# **1964 Corvette: Engineering Service Letter: Muncie Four Speed Transmission Design Change**

# ENGINEERING SERVICE LETTER

**SUBJECT:** MUNCIE FOUR SPEED TRANSMISSION - 1964 DESIGN  
CHANGE AFFECTING PAST MODELS SERVICE REPLACEMENT  
AND A FIELD FIX IF REQUIRED

**DATE** 8-20-63  
**SECTION** 7  
**MODEL** RPO M20 800-  
1200-1600-1800 & RPO  
M21-1200-1600-1800-1963

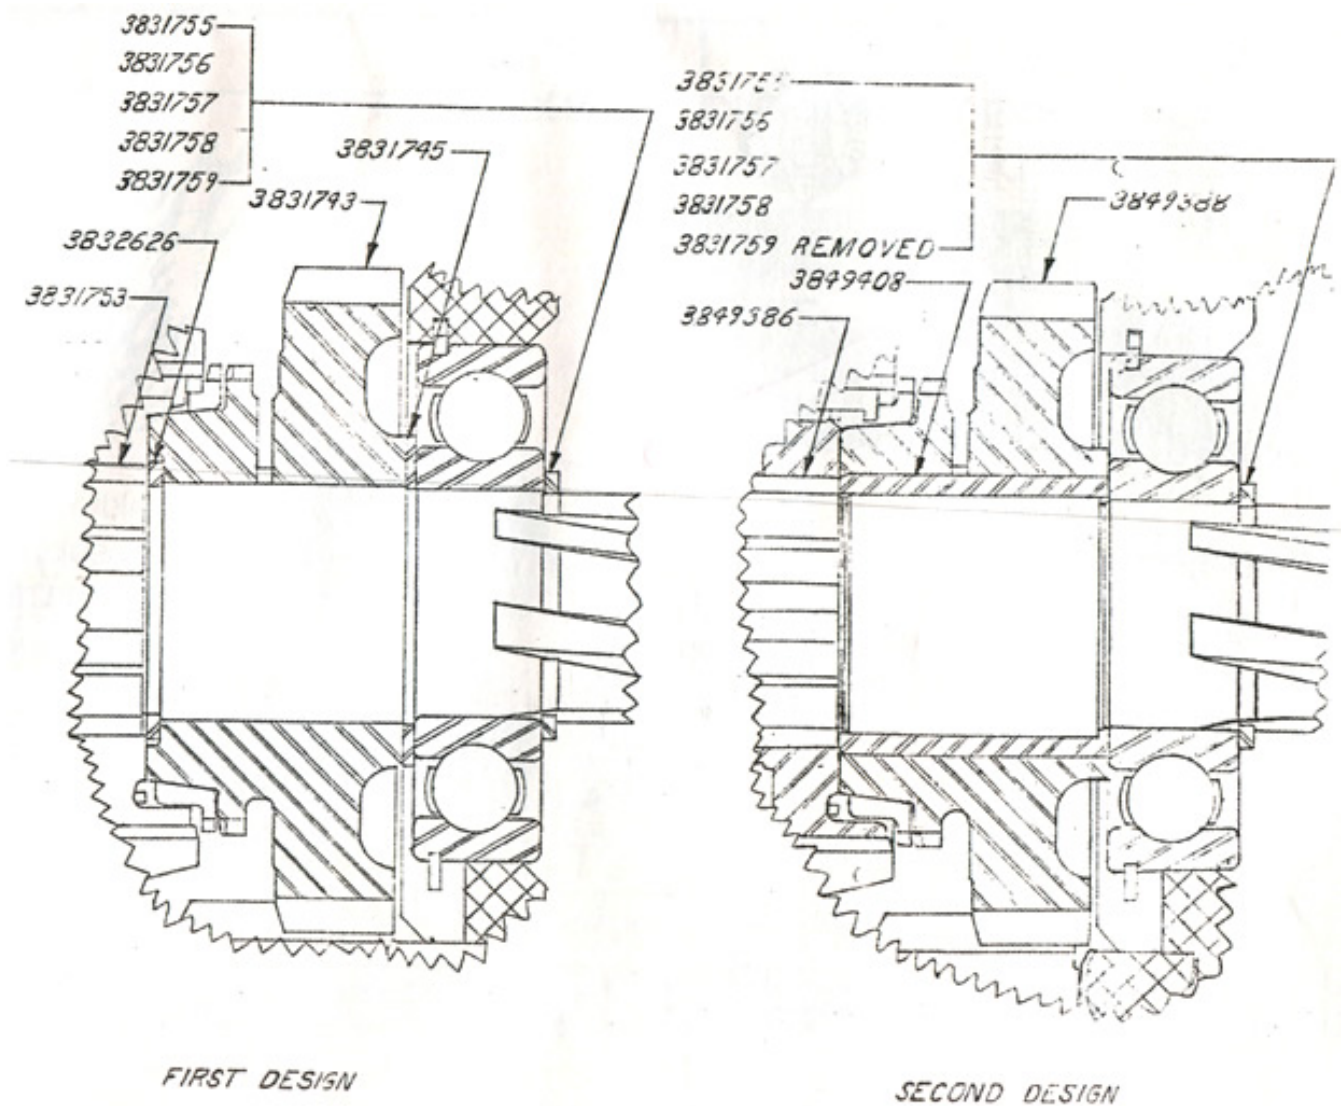
A design change is being introduced for start of production 1964 on subject transmission which includes a new transmission mainshaft, first speed gear, and first speed gear sleeve. The new parts are not interchangeable as details for service replacement on past models. The reasons for the changes are to provide positive first speed gear end clearance, and also to eliminate the possibility of seizure between the inside diameter of the first speed gear and the matching mainshaft outside diameter by use of a new sleeve. The seizure has been reported from the field in several instances at relatively low mileage, and the new parts indicated above are to be used for past model service replacement if this type of transmission failure is noted.

<u>New Parts</u>	<u>Old Parts</u>	<u>Name</u>	<u>Production Disposition</u>
3849386	3831753	Shaft - Trans. Main	Cancelled & Repl. by 3849386
3849388	3831743	Gear - First Speed	Cancelled & Repl. by 3849388
3849408	-----	Sleeve - First Speed Gear	New
-----	*3831745	Washer - 1st Speed Gear Thrust	Cancelled & Not Replaced
-----	*3831759	Ring - Trans. Main Shaft Rear Brg. Retainer	Cancelled & Not Replaced
-----	*3832626	Ring - Trans. 1st & 2nd Synchronizer Retaining	Cancelled & Not Replaced

For a comparison between the new and old design in the transmission area affected see attached sketch. Old parts indicated by an asterisk (\*) are no longer required as part of revised design.
